Submission for the **Chatswood to Sydenham Metro Line**

CHATSWOOD-SYDENHAM METRO: SS15 7400 (the Proposal)
DELETE PERSONAL INFORMATION BEFORE PUBLICATION

**SUBMISSION TO DEPARTMENT OF PLANNING & ENVIRONMENT
SYDNEY METRO-CHATSWOOD TO SYDNEHAM - REF: SSI 7400**

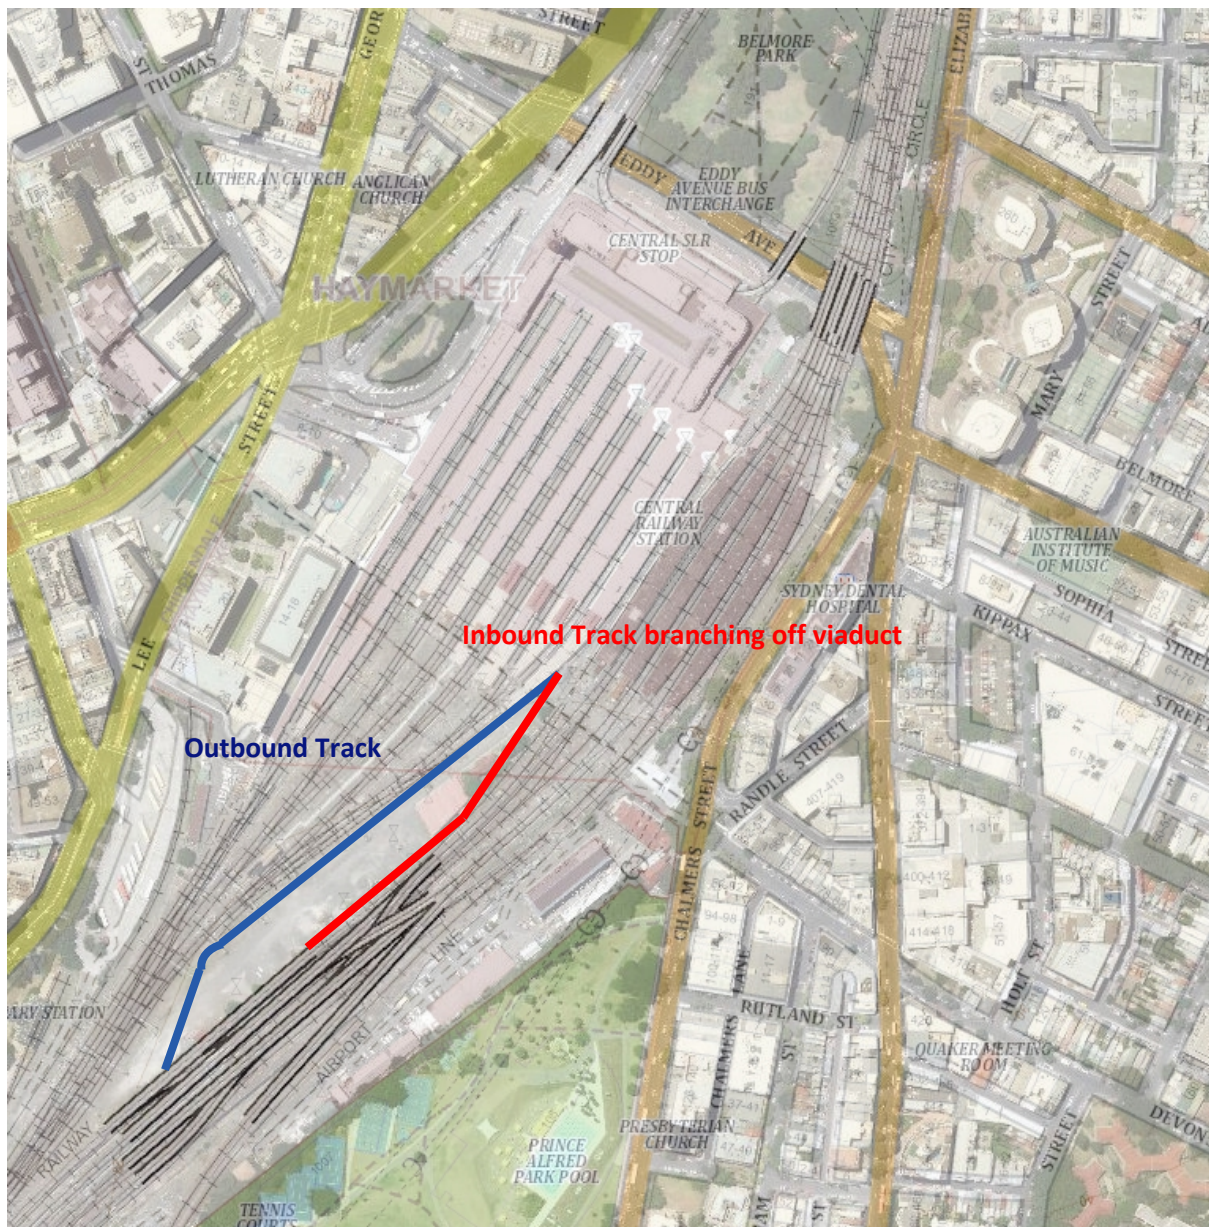
The proposal to integrate Platform 15 as a terminating suburban platform is supported. This needs to operate as an effective turnback point for outer suburban trains while permitting brief headways between train arrivals. The platform would ideally therefore connect to the suburban rail tracks, rather than the congestion-prone array of bifurcating intercity tracks that invariably impair train speeds in both directions between the Cleveland Street underpass and the terminal at Central.

Works in the Sydney Yard area of Central are required under this project. It would be most practical to incorporate new rail track connections for the rebuilt Platform 15 around the margins of this yard alongside the metro construction program. A rough visual representation of the connectivity being suggested is shown below.

Platforms 13-15 should be reinstated with sufficient length to accommodate 10 carriage train arrays, as may be required in the future for some outer suburban Sydney Trains services to meet patronage growth.

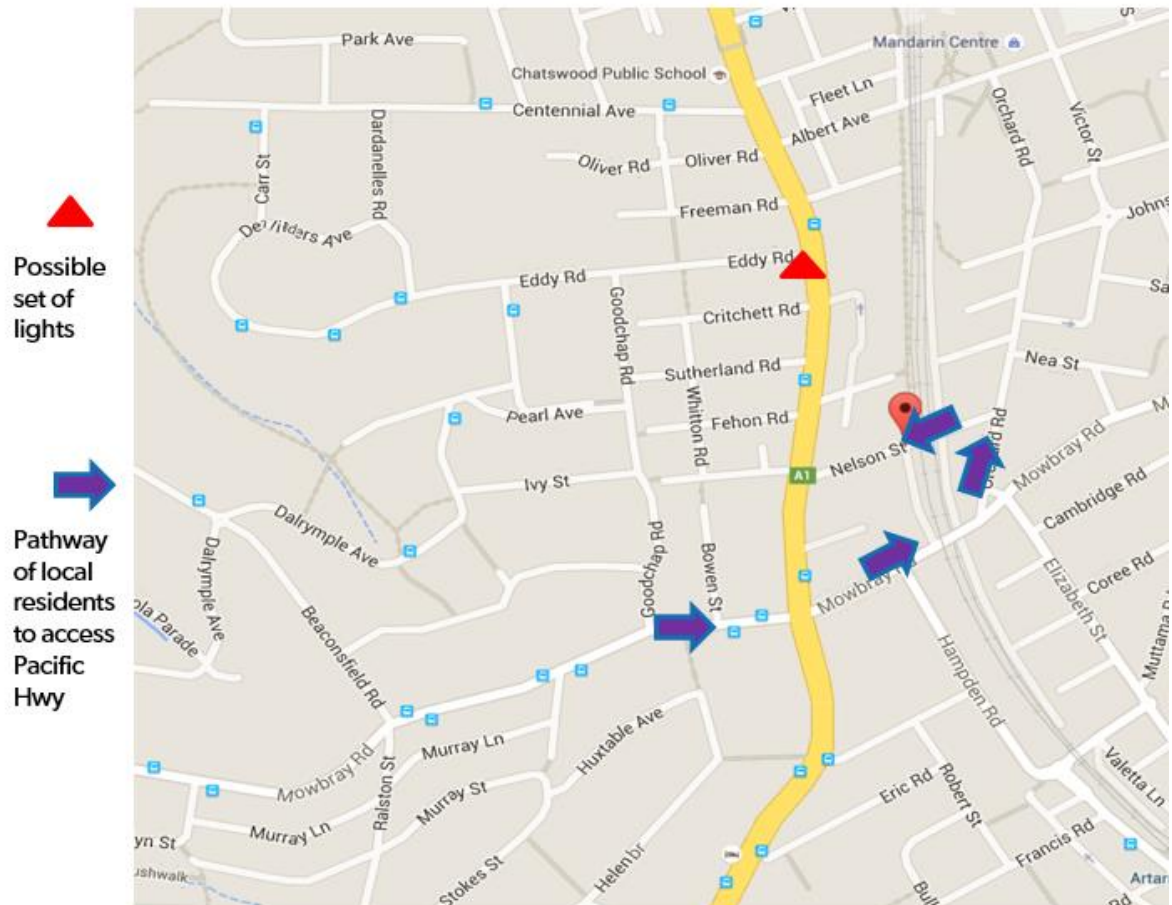
A sensible solution would be to provide a set of lights with a right hand turn, at Eddy Ave onto the Pacific Highway. This would help relieve the pressure on Centennial and provide a route for the local community who are affected by the Nelson St closure.

I have provided an illustration below and I would welcome the opportunity to discuss this issue further. I can be contacted on 0407 232 409.

"A"

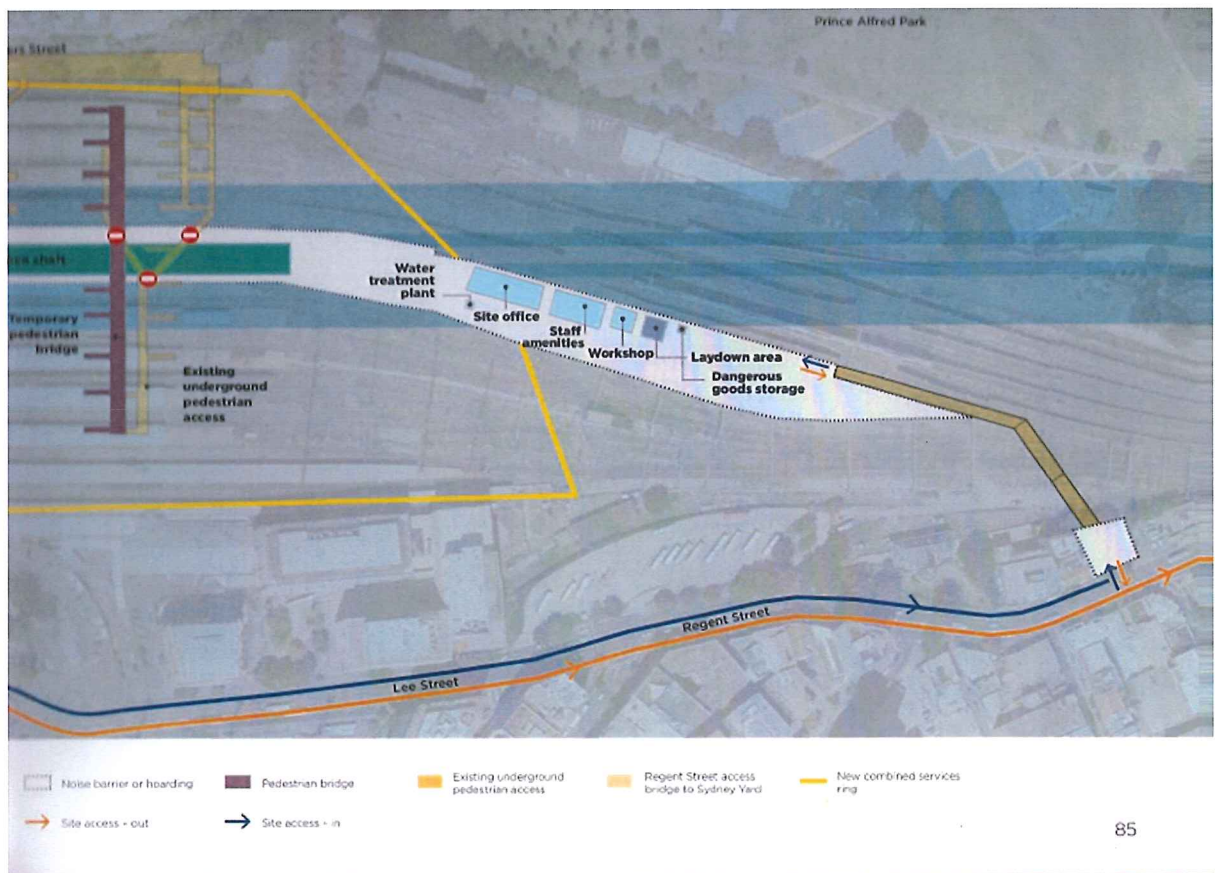
The **attached** photographs marked "A" clearly show an adverse impact on the building's Regent Street heritage context in the short term and the long term is simply unknown.

Figure 11-3 Predicted ground-borne noise levels – residential receivers

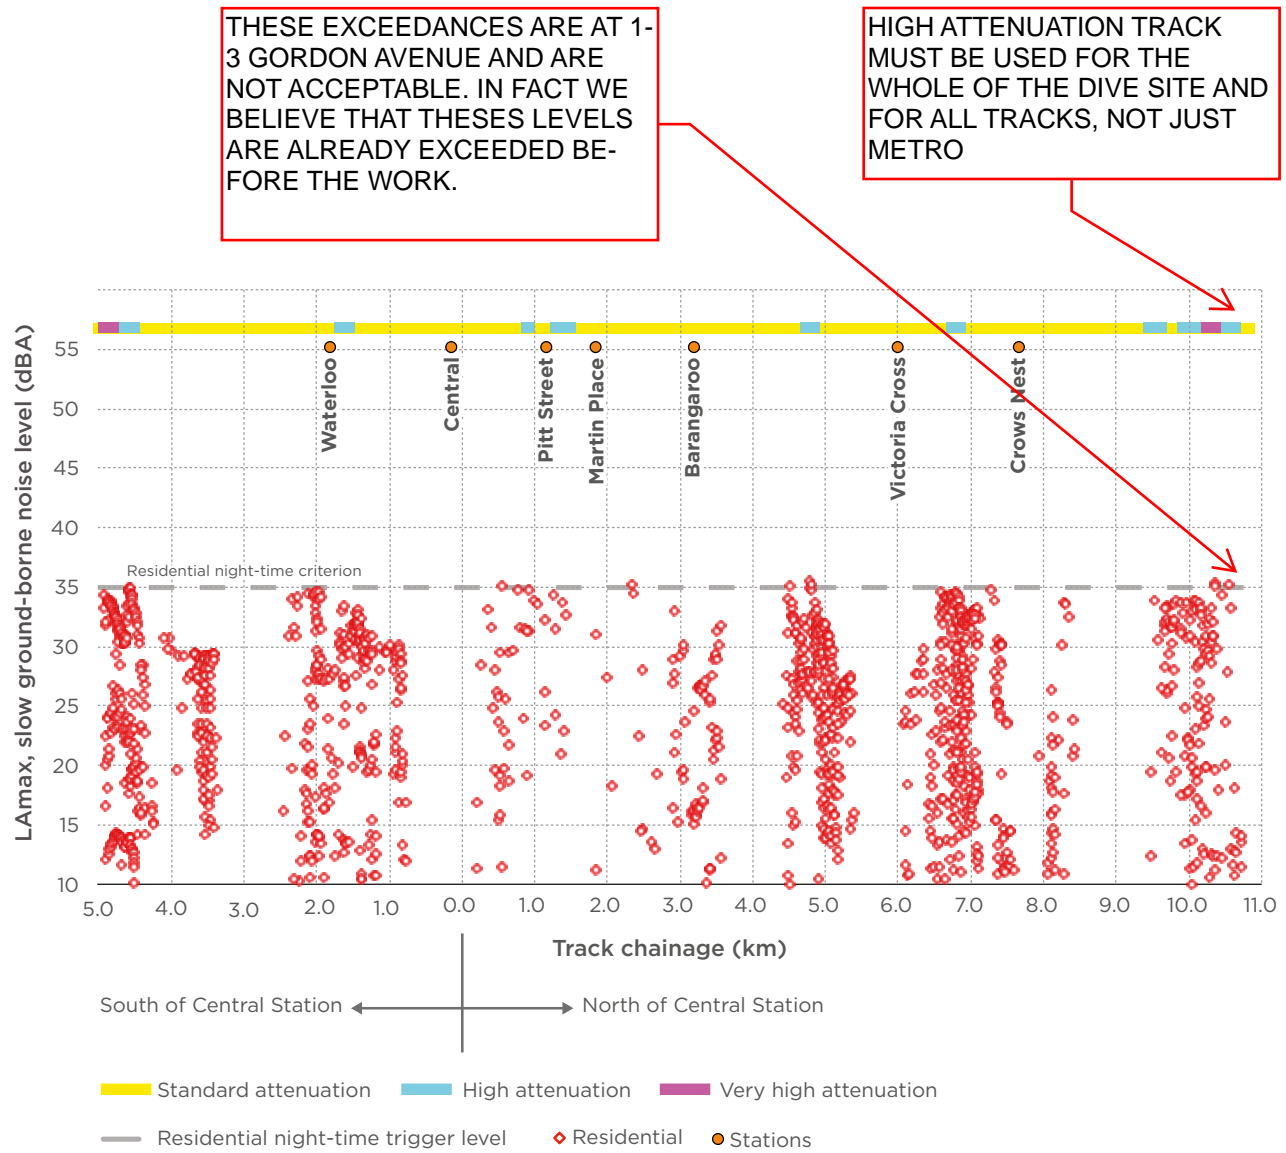
THIS AFFECTS 1-3 GORDON AVENUE AND IS NOT ACCEPTABLE TO US. THE EXISTING VIBRATION AND NOISE IS EXCESSIVE AND WE WILL NOT TOLERATE ANY INCREASE, IN FACT WE DEMAND ACTION BE TAKEN TO IMPROVE THE EXISTING PROBLEMS BEFORE ANY NEW WORK IS APPROVED

THIS INCREASE OPPOSITE 1 GORDON ACTUALLY WILL CREATE GREATER REFLECTED NOISE TO THE UPPER FLOOR OF OUR BUILDING.
